**Comment Letter 7: Adams Broadwell Joseph and Cardozo (October 19, 2015)**

**Re: Comments on the Recirculated Draft Environmental Impact Report for the Willow Springs Solar Array Project (PP10232) (State Clearinghouse No. 2010031023)**

**Figure 2.** Frequency of mountain plover detection in the Antelope Valley, California.<sup>149</sup> Graph demonstrates surveys at the Project site were conducted after most mountain plovers have left their wintering grounds.

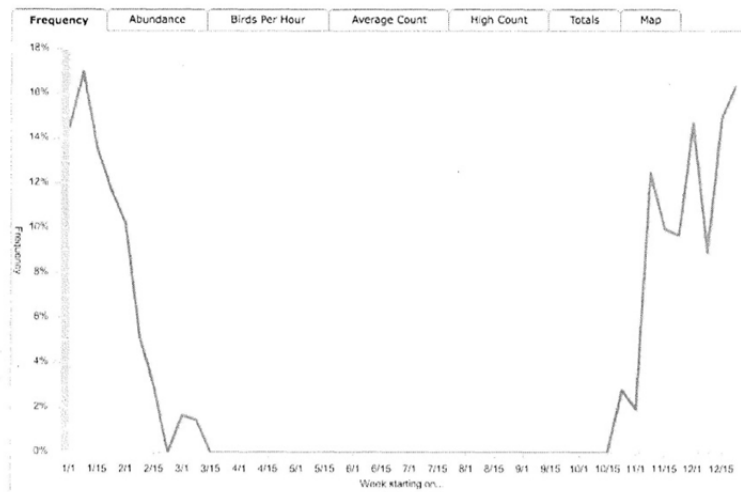
Although the RDEIR acknowledges the Project site provides suitable habitat for mountain plovers, the County ultimately found a “low” potential for the species to occur on the Project site because it was absent during the surveys.<sup>146</sup> However, as Cashen points out, Ironwood never conducted focused surveys for mountain plovers. As Figure 2 below from eBird’s database show, the surveys were conducted for other taxa and did not coincide with the time of year mountain plovers are even present in California.<sup>147</sup> Consequently, Cashen concludes the RDEIR lacks any evidence to support its claim that the species has a low potential to occur at the Project site.<sup>148</sup>

**Figure 3.** Silvery legless lizard range in California.<sup>171</sup> Arrow points to approximate location of the Project site.

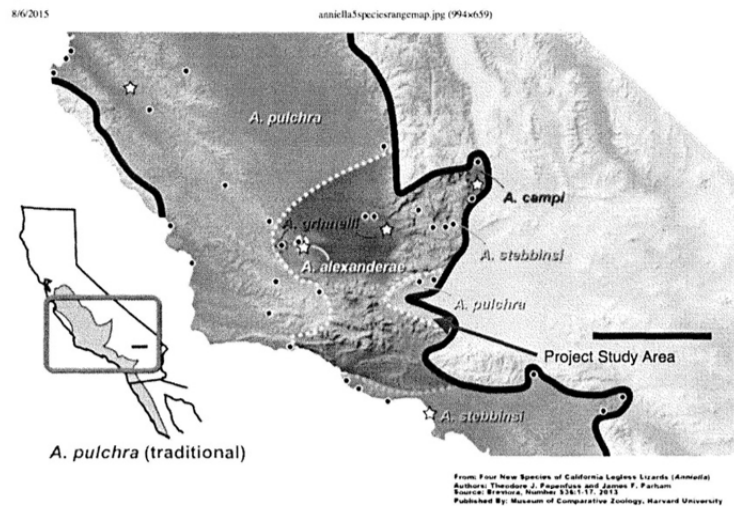
the species is usually found near sources of water in the desert.<sup>167</sup> Second, the statement that “the closest known habitat to the project site is in the Tehachapi Mountains” is simply not accurate. A silvery legless lizard was recently detected at the site for the proposed Del Sur Solar Project, which is approximately 6.25 miles south of the Project site.<sup>168</sup> Moreover, both the Biological Resources Technical Report (“BRTR”) and the “Project Impacts” section of the RDEIR acknowledge the Project site contains suitable habitat for the species.<sup>169</sup> As shown in Figure 3 below, there is substantial evidence of a distinct population of silvery legless lizards living in the Antelope Valley.<sup>170</sup>
